DESCRIPTION AND SAFETY ANALYSIS
OF PROPOSED CHANGE NPF-10/15-224 (REV. 4)

This is a request to revise Technical Specification 3/4.7.1.5, "Main Steam Line Isolation Valves," and Technical Specification 3/4.7.1.2, "Auxiliary Feedwater System."

DESCRIPTION AND SAFETY ANALYSIS
OF PROPOSED CHANGE NPF-10/15-231

This is a request to revise Technical Specification 3/4.1.3.6. "Regulating CEA Insertion Limits."

Figure 3.1-1

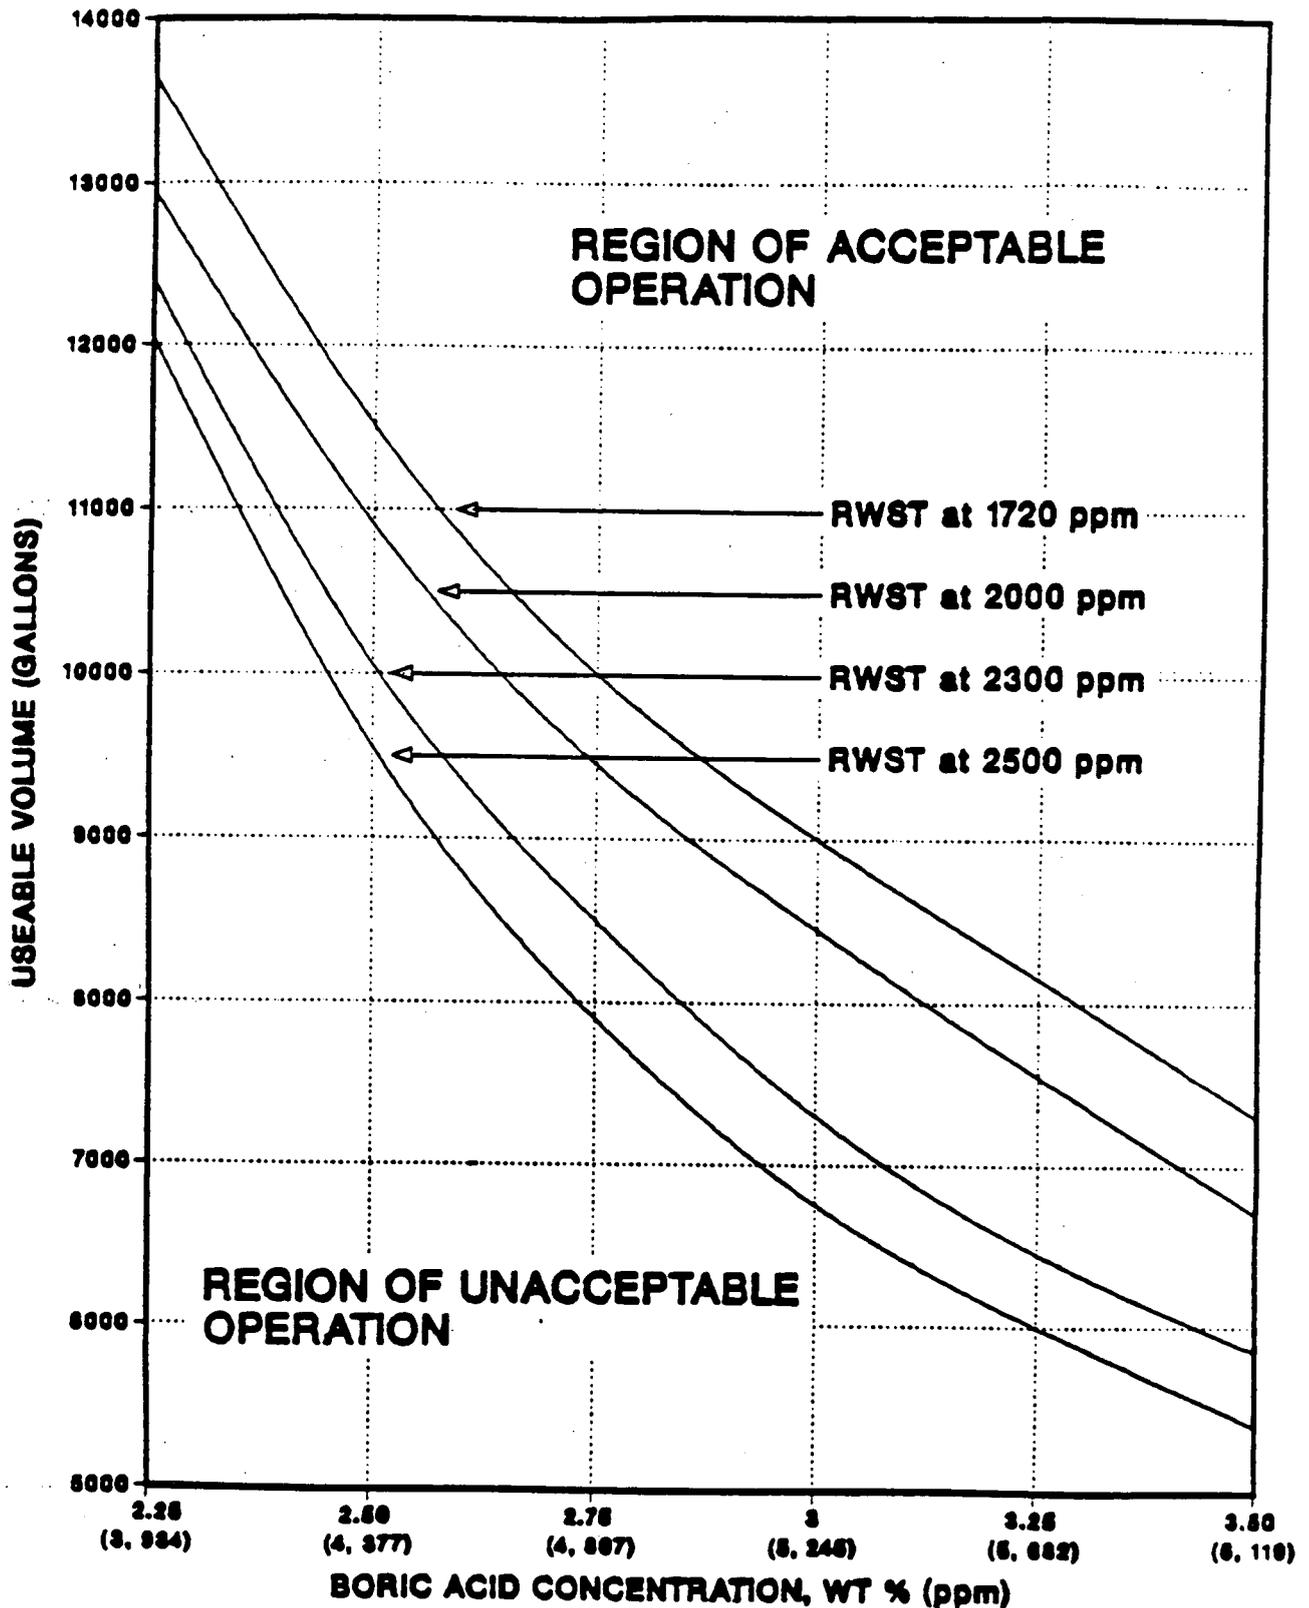
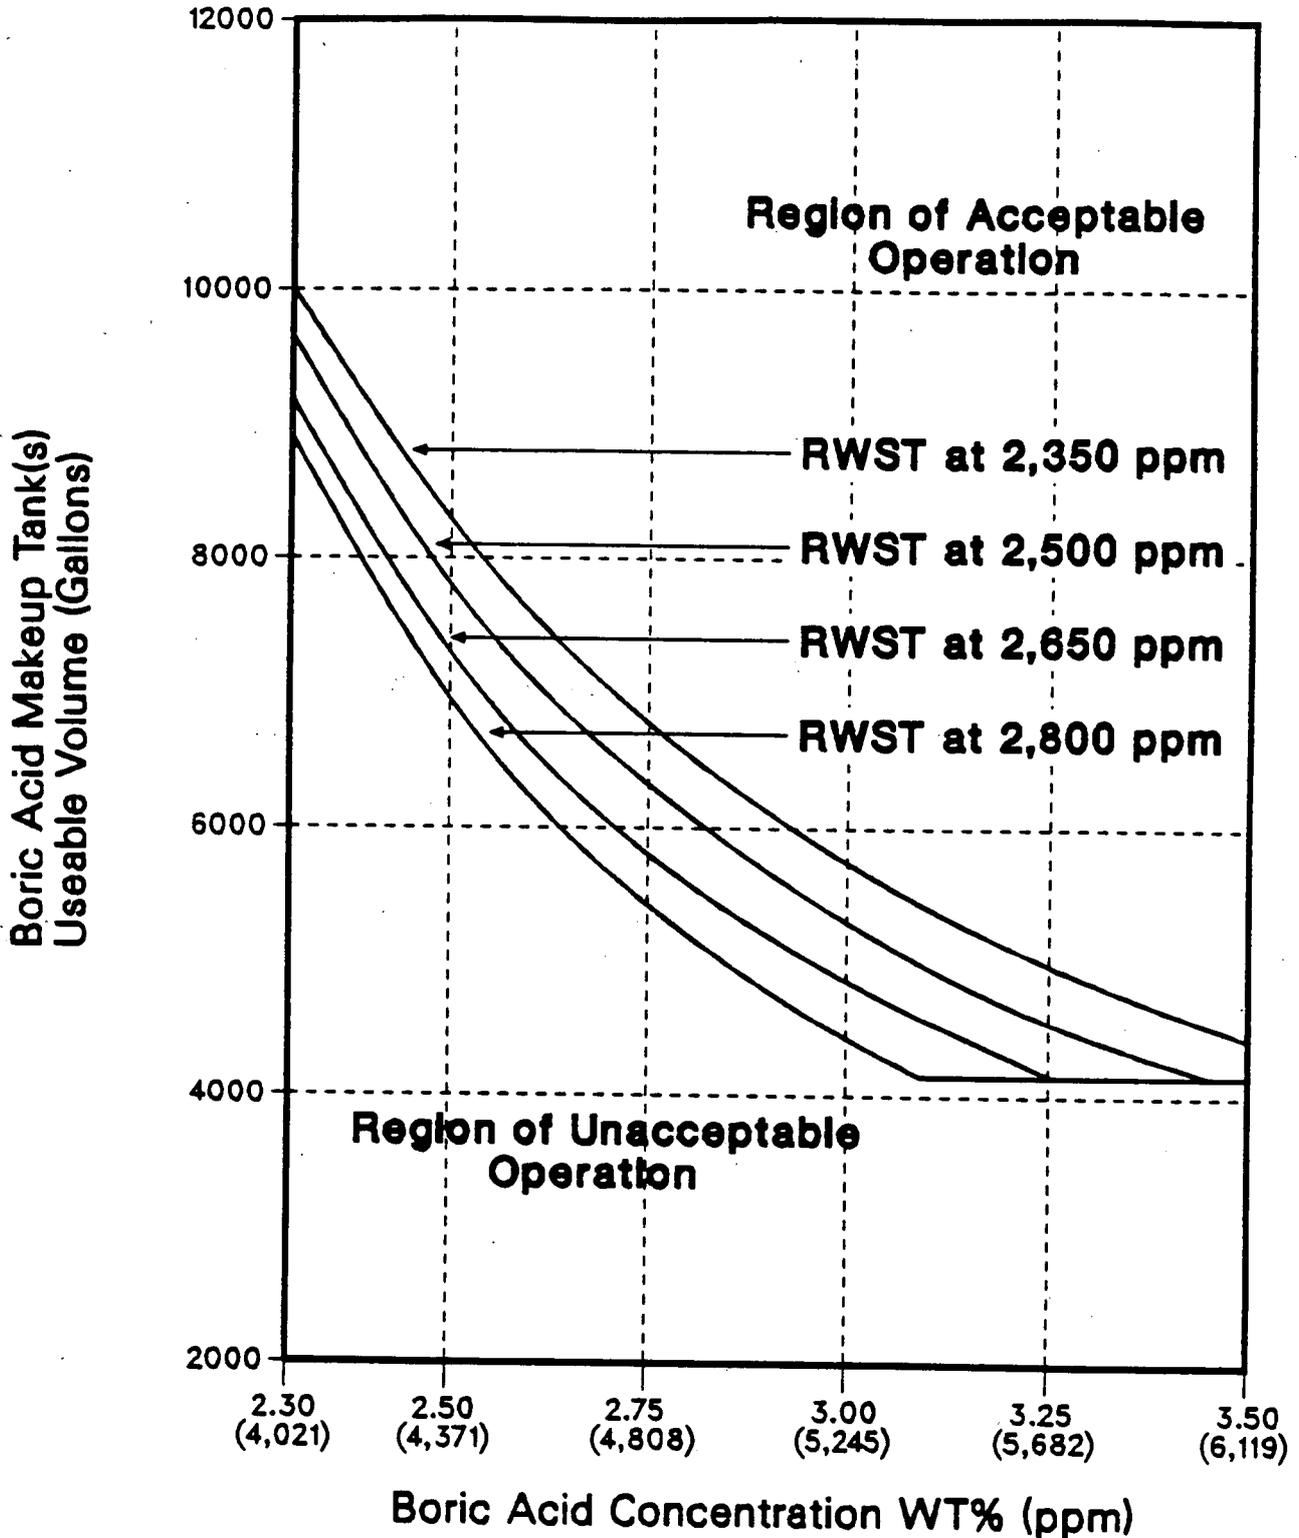
3) Revisions to Figure 3.1-1

Figure 3.1-1 define the volumes and concentrations of boric acid to be maintained in the BAMU tanks corresponding to various RWST concentrations. Currently Figure 3.1-1 incorporates four curves which represent the minimum boric acid volume as a function of concentration required from BAMU tanks for RWST concentrations of 1720, 2000, 2300, and 2500 ppm. The proposed change revises Figure 3.1-1 to include four curves for RWST concentrations of 2350, 2500, 2650 and 2800 ppm, the new range of RWST concentrations described above. The new curves were generated using the same methodology as was used for the existing curves which is documented in CEN-316, "Boric Acid Makeup Tank Concentration Reduction Effort" and was previously reviewed and approved for San Onofre Nuclear Generating Station Units 2 and 3, in conjunction with the issuance of Amendments 43 and 32 respectively. The proposed figure ensures that sufficient inventory is maintained in the BAMU tanks to support a natural circulation cooldown while maintaining 5.15% shutdown margin, to the point where the cooldown can continue to cold shutdown with inventory and boron addition from the RWST, assuming a loss of offsite power, a limiting single failure and that the letdown line is unavailable. The minimum BAMU tank inventory specified in Figure 3.1-1, 4151 gallons, is sufficient to support credit taken for charging pump operation in a postulated small break LOCA.

Borated water from the BAMU tanks and RWST are required for reactivity control and makeup during cooldown. The limiting cooldown scenario is that analyzed to demonstrate conformance with Branch Technical Position RSB 5-1. This scenario assumes that letdown is unavailable, a loss of offsite power, and the limiting single failure. Sufficient borated water must be available to maintain shutdown margin and makeup for RCS coolant contraction during cooldown. The proposed Figure 3.1-1 was developed from the same methodology as was used for the current Figure 3.1-1 approved by Amendment Nos. 43 and 32 and described in CEN-316. The higher RWST concentrations proposed result in lower BAMU tank inventory requirements.
